RHODE ISLAND ATOMIC ENERGY COMMISSION

Rhode Island Nuclear Science Center
16 Reactor Road
Narragansett, RI 02882-1165

Re: Letter dated 13 April 2010
Docket No. 50-193

Second Response to Request for Additional Information Letter Dated April 13, 2010

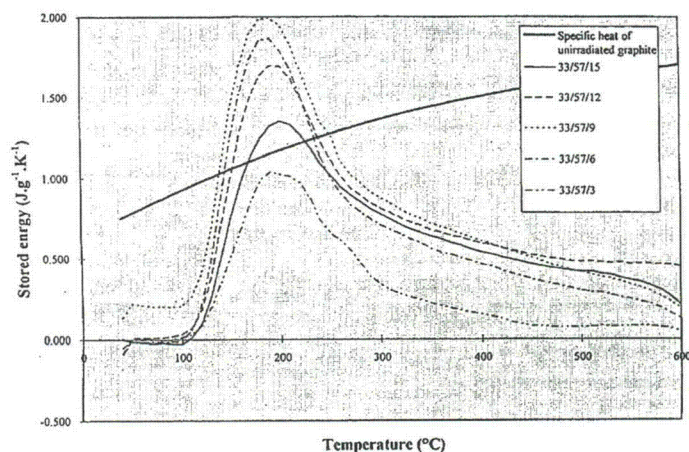
- 10.3 Section 10.2.4 discusses the thermal column experiment facility. The discussion states that cooling air is required to remove heat generated in the thermal column graphite in order to prevent the graphite from overheating. However, there is no analysis of the flow rate necessary to adequately cool the graphite, and TS 3.2.1 does not provide a set point for the safety channel associated with the thermal column. Provide an analysis of air cooling of the graphite that includes the minimum flow rate necessary to cool the graphite. Explain the basis for the graphite temperature limit of 107 degrees C. (See RAI 14.74)

The temperature limit of 107 °C is cited in the original reactor operating manual [Operation and Maintenance Manual, One-Megawatt Open Pool Reactor for Rhode Island Atomic Energy Commission, Providence, R.I., General Electric Document GEI-77793, October 1962] but no basis is

given. Since the ignition temperature of graphite is well above this temperature (ranging from approximately 400 °C upwards, depending on the specific type and form of the graphite) it is reasonable to assume the limit was placed on the graphite temperature to preclude any unexpected releases of the stored lattice energy (i.e., Wigner energy) induced by neutron irradiation.

As neutron-irradiated graphite is annealed (heated above irradiation temperatures) little or no stored energy is released below approximately 100-125 °C. A significant release peak occurs at approximately 200 °C, so limiting the RINSC thermal column graphite to temperatures below 107 °C provides a margin of nearly a factor of two to this energy release temperature. It is not credible that the entire thermal column contains lattice defects. The threshold energy for the lowest form of induced defect is approximately 1 eV (see Telling paper). After passing through the first several inches of graphite, the neutron flux in the thermal column is, as the name indicates, thermalized to an energy spectrum with a peak near 0.025 eV, which is below the threshold for inducing lattice defects. The figure below shows the energy release rate as a function of temperature (from Ref. 2 above).

The only graphite that is exposed to neutrons of energies of 1 eV or greater is the graphite in the first several inches toward the core. This section of the graphite protrudes into the reactor pool via the thermal column extension. Consequently, the cooling for this is provided by the reactor pool rather than by airflow through the thermal column. The purpose of the airflow is to prevent Ar-41 from being released into the reactor room. As a result, no airflow rate specification is needed.
